Haynes Elementary School

Town of Sudbury ADA Transition Plan

January 2021

Institute for Human Centered Design

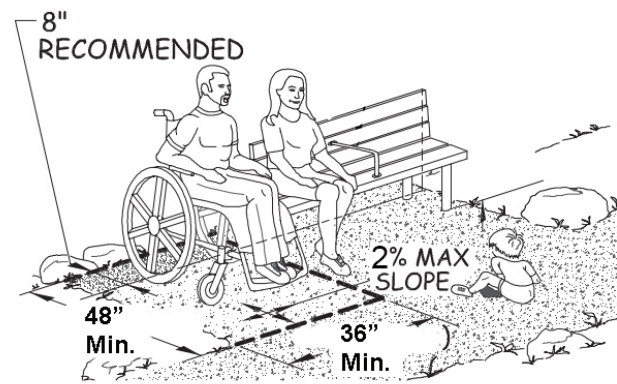
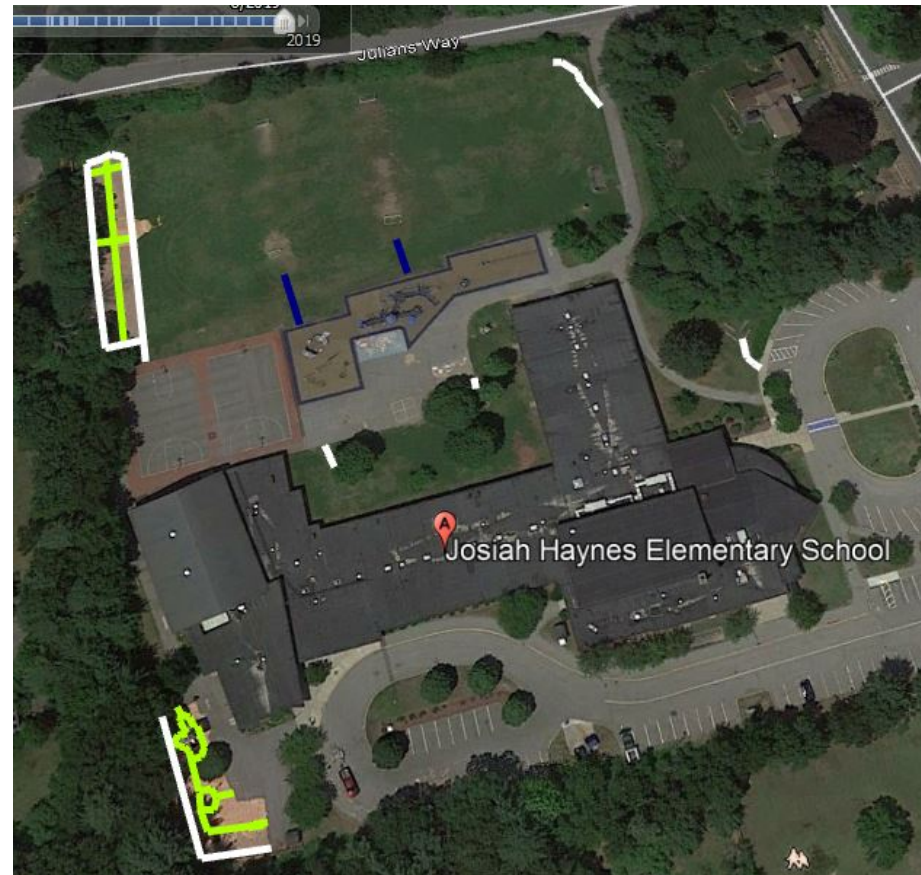
- Recommend providing accessible signage on the latch side of the door at all permanent rooms that lack signs.
- Recommend providing directional signage to the accessible route to the stage.
- Recommend locating some coat hooks in the main corridor within recommended children's reach ranges between 40" and 44" high for students in the kindergarten through the fifth grade.
- Recommend providing an accessible walkway from each ground level classroom exit door to the north walkway.
- Recommend providing a 10" high solid surface kickplate on the push side of the gate to the southwest playground.
- Recommend providing a 48" wide accessible route around the entire picnic table at each accessible picnic table. See the following image:

- Recommend providing a 36" x 48" space alongside one bench positioned so that a person using a wheelchair can sit shoulder to shoulder with someone seated on the bench. See following image:
